APPEAL SUMMARY

Appeal ID: 23802	Project Address: 7000 NE Airport Way
Hearing Date: 6/10/20	Appellant Name: Tom Jaleski
Case No.: B-010	Appellant Phone: 9712385266
Appeal Type: Building	Plans Examiner/Inspector: Guy Altman
Project Type: commercial	Stories: 2 Occupancy: A-2, A-3, B, M, S-1 Construction Type: I-A
Building/Business Name: PDX Whole Building	Fire Sprinklers: Yes - throughout
Appeal Involves: Erection of a new structure	LUR or Permit Application No.:
Plan Submitted Option: pdf [File 1]	Proposed use: Airport

TCORE - ATO PRE-MANUFACTURED TRAILERS
CODE ANALYSIS - FIRE LIFE SAFETY SITE PLAN

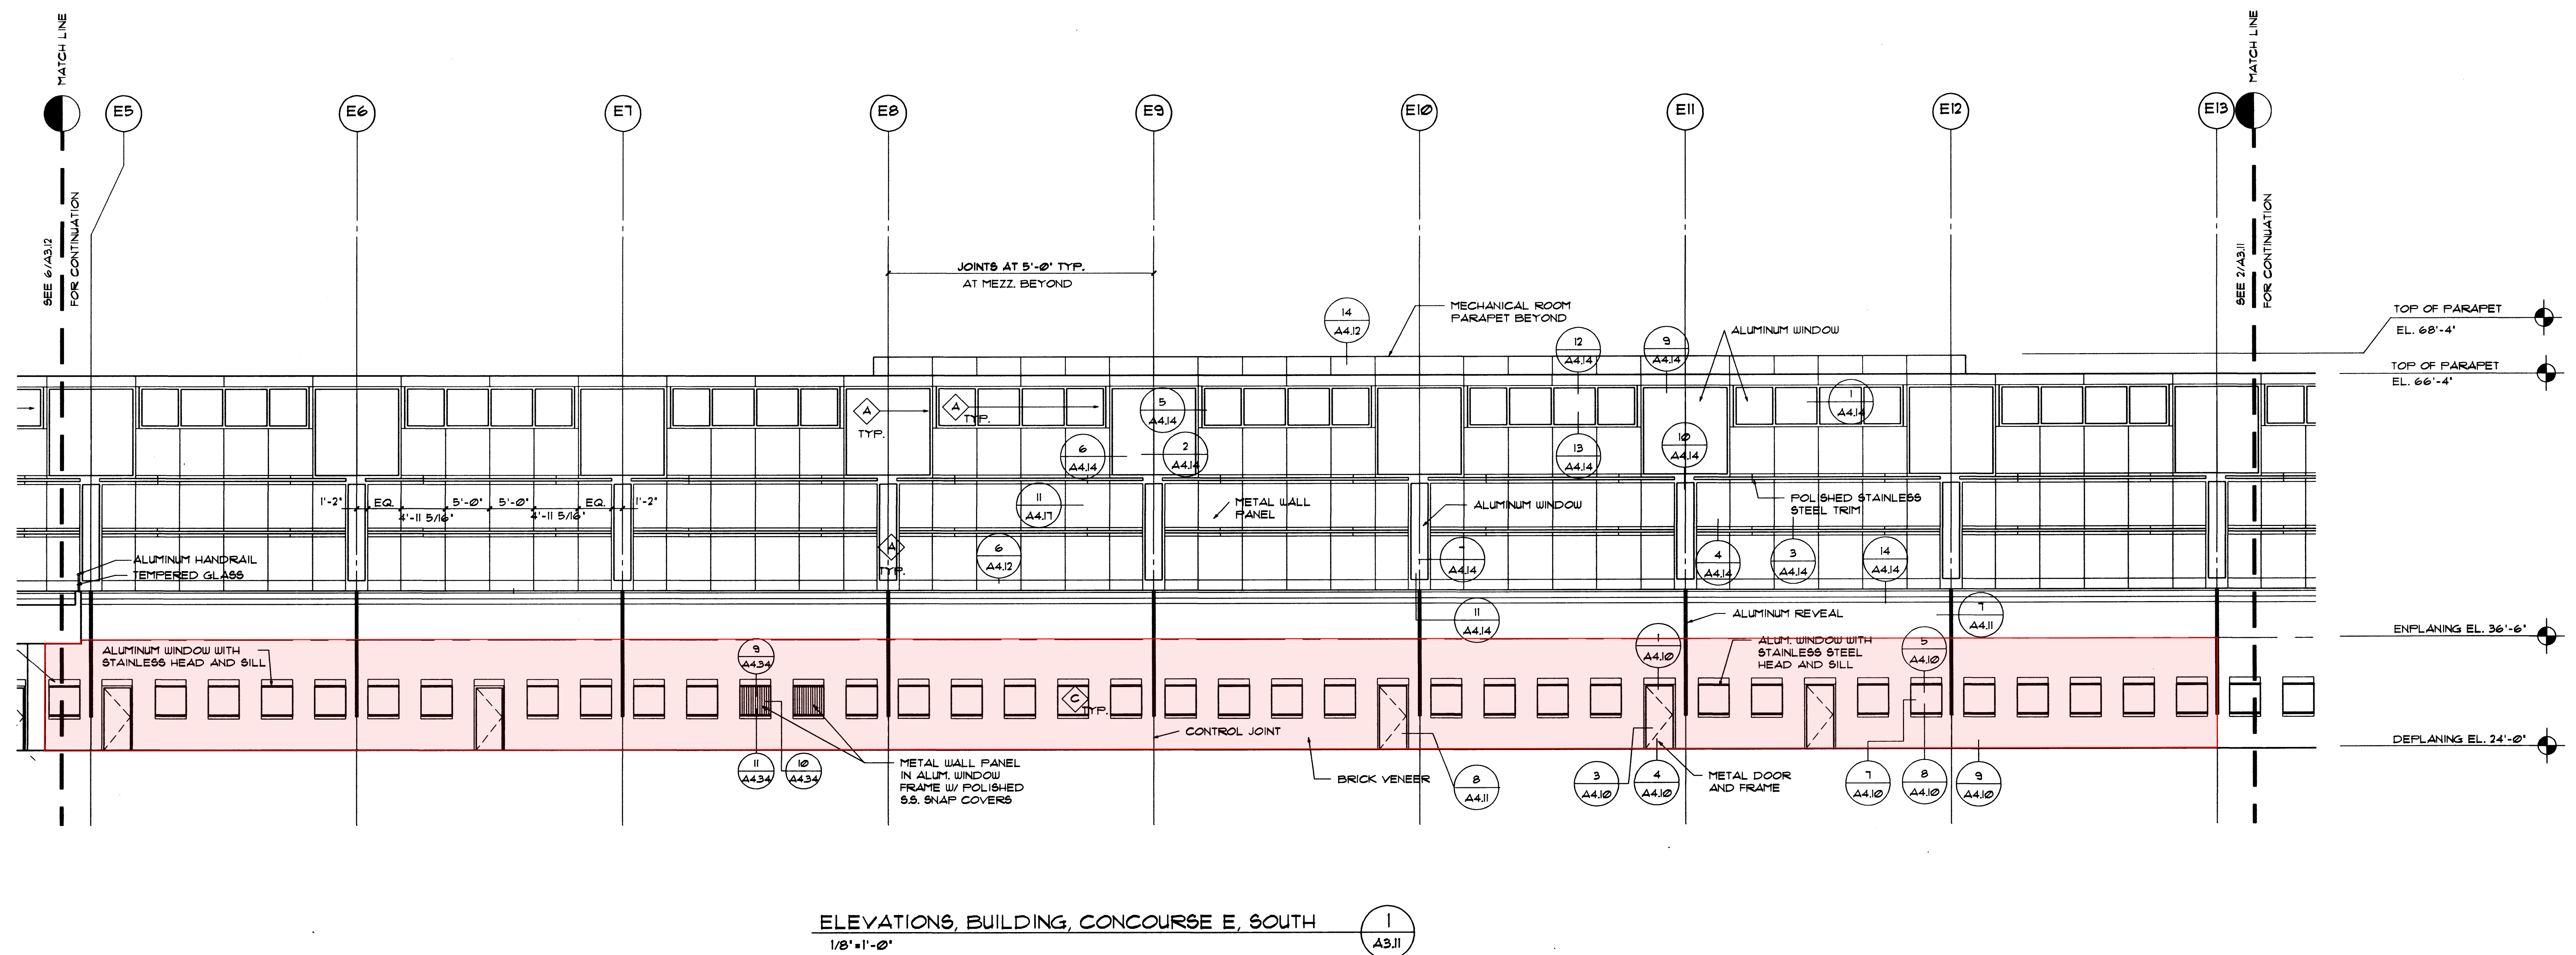
Code Section	1021.4
Requires	<p>1021.4 Location. Exterior egress balconies shall have a minimum fire separation distance of 10 feet measured at right angles from the exterior edge of the egress balcony to the following:</p> <ul style="list-style-type: none"> Adjacent lot lines Other portions of the building Other buildings on the same lot unless the adjacent building exterior walls and openings are protected in accordance with Section 705 based on fire separation distance.
Code Modification or Alternate Requested	The proposed design for an egress balcony within 10' of another building on the same lot is provided equivalent protection by exceeding the requirements of an egress court by providing 1 hour rated walls on each side of the court and 2 means of egress from the egress court.
Proposed Design	<p>The Portland International Airport (PDX) is a fully sprinklered building of Type IA construction. Trailers of Type VB construction to be used for no more than 5 years are proposed to be placed 10'-1" from the existing PDX deplaning wall.</p> <p>The proposed design is for temporary trailers of Type VB, unsprinklered construction to house Port of Portland office functions to exist 10'-1" from the existing terminal building. Egress for ATO-3, ATO-4, ATO-5, and ATO-6 use an exterior walkway as a second means of egress and is closer than 10' to the existing PDX building wall. The egress balcony will provide equivalent protection for egress as follows:</p> <ul style="list-style-type: none"> The trailers are 10'-1" from the terminal building providing an egress court per 1028.4.2 with 1 hour rated walls each side. The egress court has 2 means of egress to a public way. The egress balcony, stair and ramp is of non-combustible construction.

Reason for alternative The intent of OSSC 1021.4 is to ensure that occupants can egress out of the building and not be impeded by a fire smoke event. The walls of the trailers facing the existing PDX terminal walls are 1 hour rated as required for a fire separation distance (FSD) of 10' per Table 602. The existing walls of the PDX terminal at the deplaning level are of CMU construction with 15% openings, exceeding 1 hour fire rating for the wall and less than the 45% of unprotected openings percentage allowed per Table 705.8 with a FSD of 10'. The short egress balcony exceeds the requirements of OSSC 1021.2 for egress court by having 1 hour rated walls and 2 means of egress.

The trailers are of modular wood construction set on the ground without a foundation. The egress for trailer marked ATO-3, ATO-4, ATO-5, and ATO-6 on the attached plan have egress routes going to an elevated walkway adjacent to the existing terminal building. The walkway has been deemed an egress balcony due to it not being at grade level. The balcony serves as a second means of egress and an accessible route to these trailers. The balcony is more than 44" wide and is approximately 6' from the existing terminal wall. Existing means of egress for the terminal enters into this area as well, with access to a public way in 2 directions.

The means of egress for the existing terminal at grade and for the trailers, elevated above grade, use the egress court created between the buildings. Egress courts per OSSC 1028.4.2 are not required to have fire rated walls where the egress court is more than 10' wide and not required to have 2 egress routes from them to the public way. The intent of the allowance for non-rated walls is due to the fire/smoke event only occurring on one side of the egress court, and 10' being enough width for people to move around the escaping heat and smoke to reach the public way. The additional protection measures of fire rated walls on each side of the egress court is to provide protection for egressing occupants to exit the area. Egress courts are not required to have 2 means of egress, intended to provide a single path to the public way only. The proposed egress court has egress to the public way in 2 opposite directions, exceeding code requirements, and providing equivalent protection by egressing occupants not being required to pass by escaping heat and smoke from a fire/smoke event. The proposed trailers will have 1 hour rated walls without unprotected openings facing the existing terminal.

The proposed design of the trailers walls will meet the requirements of Table 602 for 1 hour rating with $\frac{3}{4}$ rated opening protection. The terminal walls on the deplaning level in this area are of CMU construction, providing more than 1 hour fire rating with unprotected openings meeting the requirements of Table 705.8. The egress court is more than 10' wide and provides a means of egress to a public way in 2 directions, eliminating the need for egress to pass by escaping heat and smoke. The egress balcony exceeds the code requirements of 1021.2 by providing 1 hour rated wall and protected openings with 2 means of egress. Equivalent protection for egress is provided by the rated wall on each side of the egress court and 2 means of egress from the egress court, therefore request approval of the appeal.

Egress balcony with less than 10 feet of fire separation distance to adjacent unprotected building openings: Granted as proposed.

The Administrative Appeal Board finds that the information submitted by the appellant demonstrates that the approved modifications or alternate methods are consistent with the intent of the code; do not lessen health, safety, accessibility, life, fire safety or structural requirements; and that special conditions unique to this project make strict application of those code sections impractical.
